**UPPER MORELAND TOWNSHIP**  
**Community Development Committee Meeting**  
**February 9, 2026 at 7:00 p.m.**  
**AGENDA ITEMS ARE SUBJECT TO CHANGE**

- VI. Land Development/Subdivision**
  - A. Land Development Waiver Request - 601 Davisville Road Fred Beans (attachments)
  - B. Land Development Waiver Request – 3930 Commerce Avenue (attachments)

**RECORD PLANNING  
LAND DEVELOPMENT  
601 DAVISVILLE ROAD  
UPPER MORELAND TOWNSHIP - MONTGOMERY COUNTY**

EXISTING FEATURES AND  
DEMOLITION PLAN  
607 DAVISVILLE ROAD  
UPPER MERION TOWNSHIP - MONTGOMERY COUNTY - PENNSYLVANIA

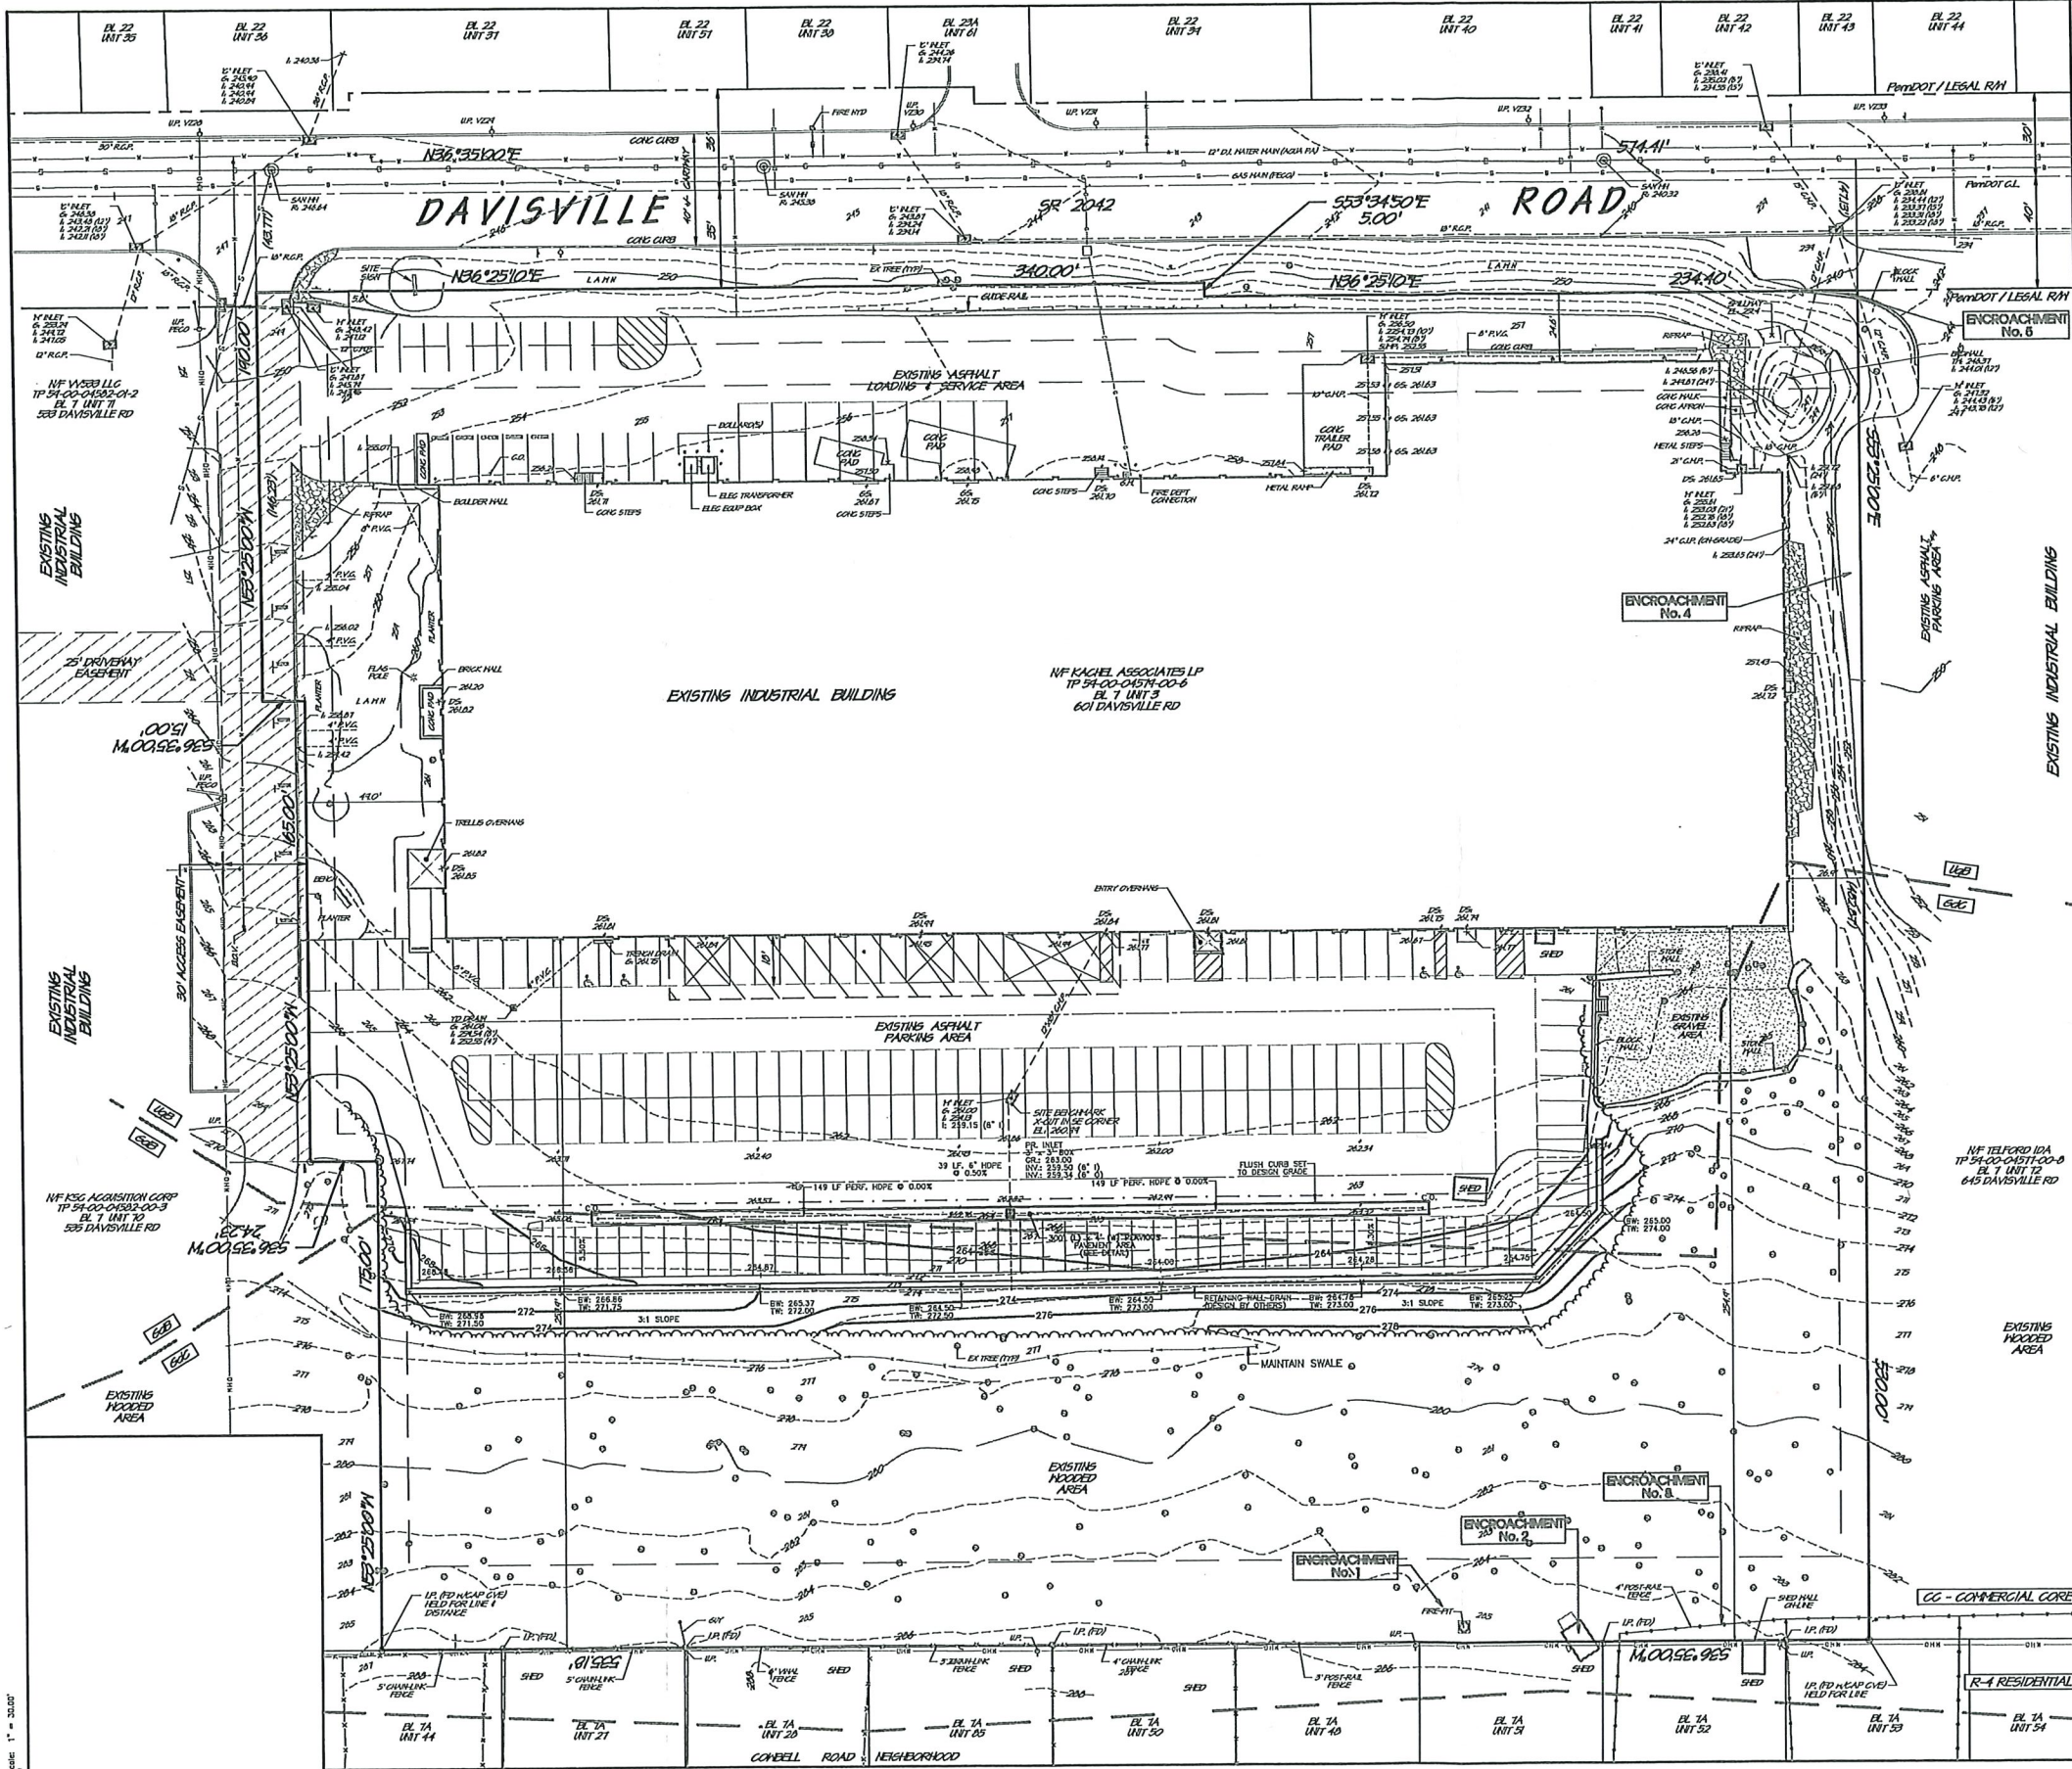
1. Verify the existing on-site parking spaces listed on Sheet 2 as the quantity listed seems low.
2. We suggest using wheel stops on the eastern parking/storage spaces along the retaining wall.
